Technical Service Bulletin

Technical Service Bulletin: TSB210225	Released Date: 15-Oct-2021
Rocker Lever Cover Interference Causing Injector Circuit Fault Codes: 322, 332, and 325

Figure 1, Interference Locations 1, 2, and 3

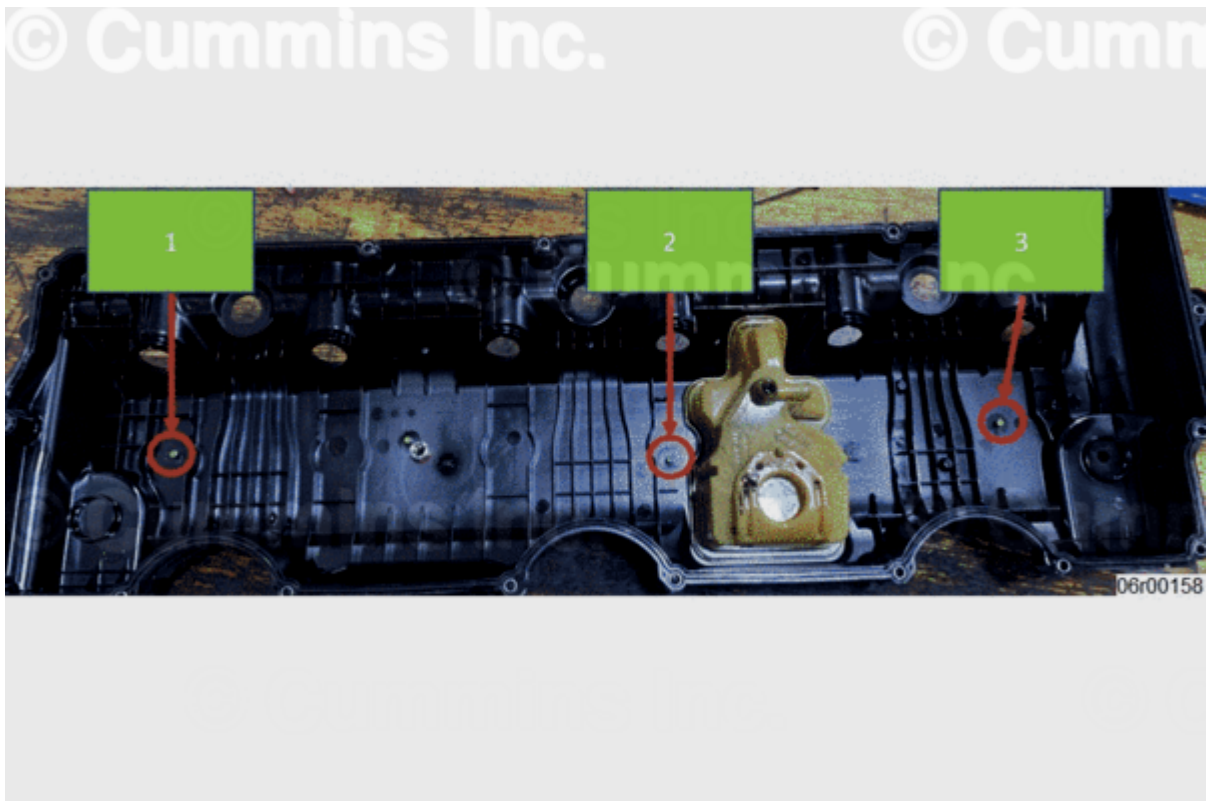
- Inside the rocker lever cover there is a potential for “nubs” made of excess flash from the injection molding process that can interfere with the injectors or injector wiring harness. This interference can lead to injector fault codes. See Figure 1 below for the location of the nubs.

1. Is near cylinder 1
2. Is near cylinder 4
3. Is near cylinder 6

- If the rocker lever cover is coming in contact with an injector or the injector wiring harness, remove all the nubs on the rocker lever cover.
- Preferred method of removal is cutting the nubs off as flush to the surface of the rocker lever cover as possible with end cutters and to avoid creating any kind of small debris that could get into the overhead system.
- If debris is generated from the removal process, verify that the rocker lever cover is thoroughly cleaned before installing on the engine.

Figure 2, Evidence of Paint on Injector Wire Caused by Interference with Nub on Rocker Lever Cover.

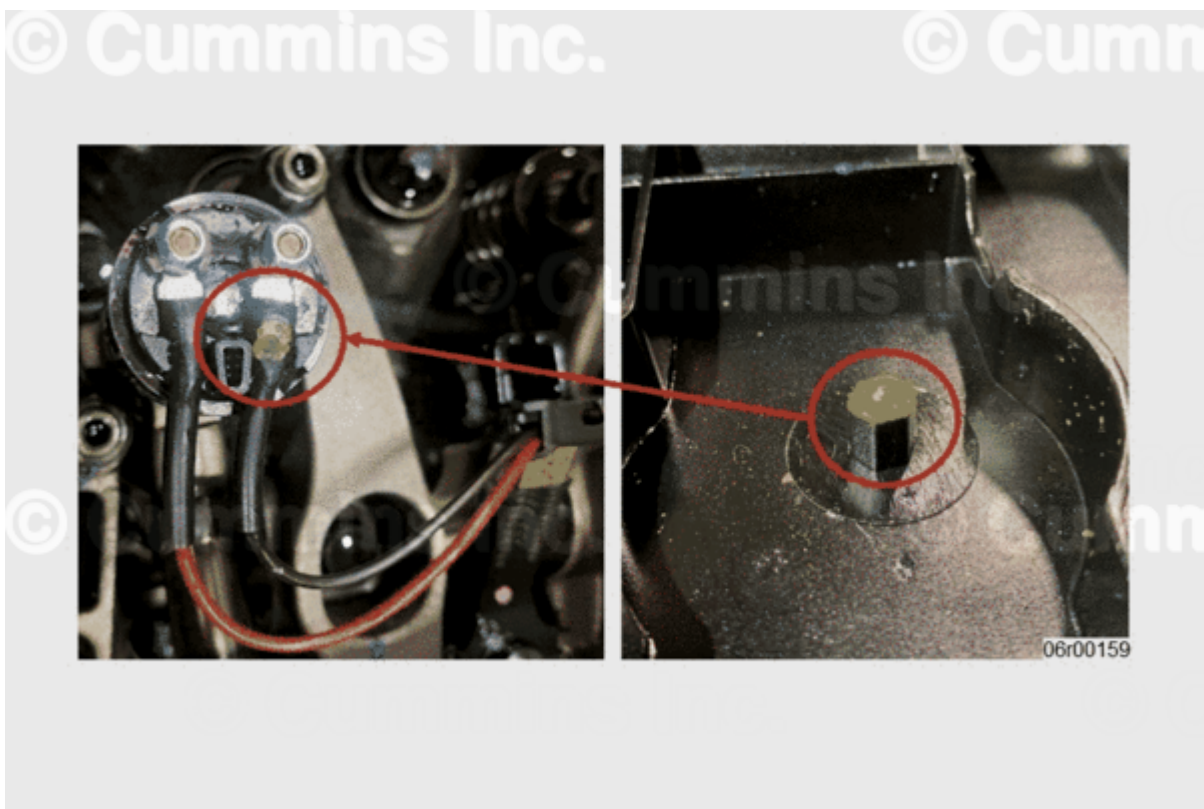
- If the rocker lever cover is interfering with the injector harness inspect for any indentations or breaks in the wiring harness
- With the rocker lever cover removed, use a paint pen to mark the nubs and install the rocker lever cover. Remove the rocker lever cover to see where signs of interference are present. See Figure 2 and Figure 3 below.

Figure 3, Evidence of Paint on Injector Nut Caused by Interference with Nub on Rocker Lever Cover.
